Appendix A: PS 059 Tunbridge Wells Local Plan Stage 3 Part 2 Outcomes – Local Capacity Sensitivity Testing Technical Note – Sweco 28.11.23 – commentary provided by the Local Highway Authority on 14 December 2023.

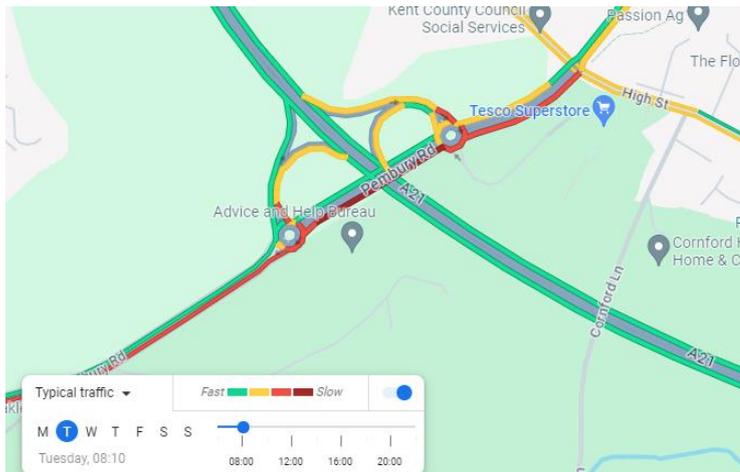
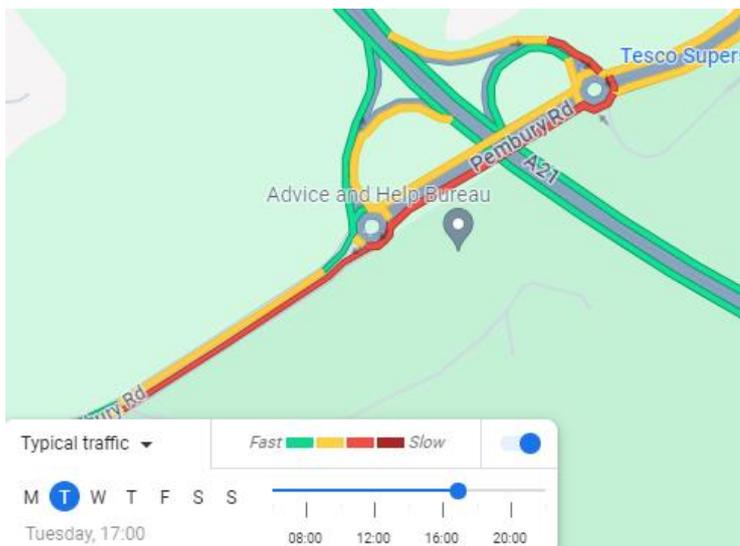
Table 9 indicates that the strategic model finds the junctions to operate within capacity in both the peak periods in the 2018 Base Case (BC). In the RC the model indicates capacity issues only on the A21 slips and Tesco access. This is not evident on the ground. Both junctions currently suffer from capacity issues in both peak periods and this can be seen from the Google extracts below:

AM Peak

PM Peak

The validation of the 2018 base case is therefore questioned with regard to these junctions.
